Ignition unit of ROTAX engine 912 UL

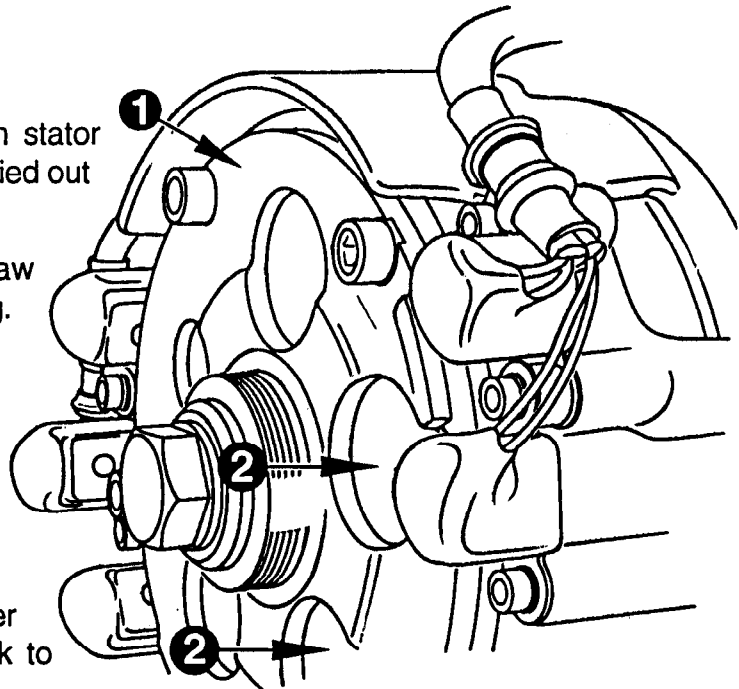
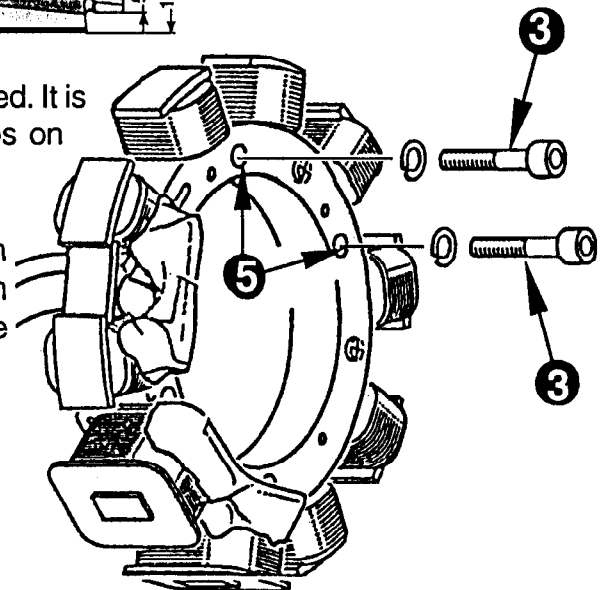
As known from experience, inadequate ground connection could arise between stator and ignition housing on the engine type 912 UL.

All engines up to engine no. 4,005.330. On all subsequent engines, measures have been taken at Rotax already.

Improve ground connection between stator and ignition housing. This can be carried out with engine installed in the aircraft.

Disconnect battery. No need to withdraw magneto housing ① with magneto ring. Remove at least 2 of the 4 Allen screws ③ and lock washers for stator attachment via the openings ② in the magneto housing.

■ **ATTENTION:** Make absolutely sure that no foreign matter (lock washer or screws) will stick to the magneto ring.

Use spot-facing cutter ④ or similar tool to machine contact face ⑤ on stator for the screws ③ removed. It is advisable to grease cutting tool to collect chips on cutter and not on magneto ring.

Refit screws M5 along with lockwasher and tighten to 6 Nm. To ensure lasting ground connection treat contact faces for screws with Lithium-base grease.

Reconnect battery and carry out ignition check.
